**PLANNED UNIT DEVELOPMENT
& SUBDIVISION STAFF REPORT****Date: May 3, 2007****DEVELOPMENT NAME**

Louise Place Subdivision

APPLICATION NUMBER 15 & 16 DATE May 3, 2007

REQUEST Subdivision, Planned Unit Development

SITE PLAN

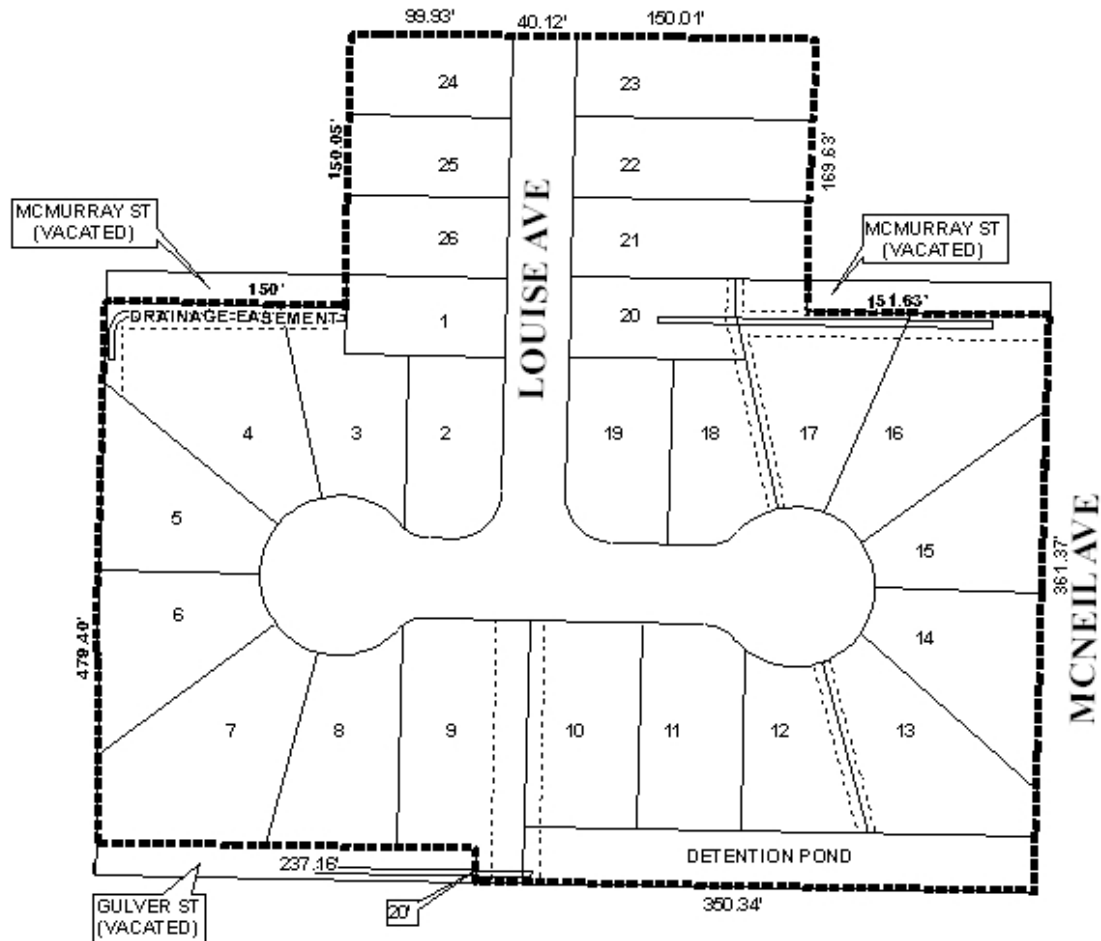
Show sanitary sewer easement on the south side of the subdivision near the detention pond. Must comply with all storm water and flood control ordinances. Any work performed in the right of way will require a right of way permit.

Common and detention areas are shown on the plat and should be labeled on the final plat and site plan and accompanied by a note stating that maintenance of all common areas will be property owners' responsibility.

Finally, the plat and site plan should be revised so that each lot is labeled with its size in square feet, or a table should be provided on the drawings with the same information.

- 6) placement of a note on the final plat stating that the site is denied access to Schaub and McNeill Avenues;
- 7) depiction of the minimum 15-foot building setback line along all lots fronting Louise Avenue and Louise Place (including the street-side side-yard setback for Lots 2 and 19);
- 8) placement of a note on the final plat stating that common area maintenance will be property owners' responsibility.
- 9) labeling of each lot with its size in square feet, or provision of a table on the plat with the same information;
- 10) placement of the PUD front, side and rear yard setback and site coverage information on the final plat, as shown on the preliminary plat;
- 11) provision of a revised PUD site plan to the Planning Section of Urban Development prior to the signing of the final plat; and
- 12) full compliance with all other municipal codes and ordinances.

- 6) placement of a note on the site plan stating that the site is denied access to Schaub and McNeill Avenues;
- 7) depiction of the minimum 15-foot building setback line along all lots fronting Louise Avenue and Louise Place (including the street-side side-yard setback for Lots 2 and 19);

- 8) placement of a note on the site plan stating that common area maintenance will be property owners' responsibility;
- 9) labeling of each lot with its size in square feet, or provision of a table on the site plan with the same information;
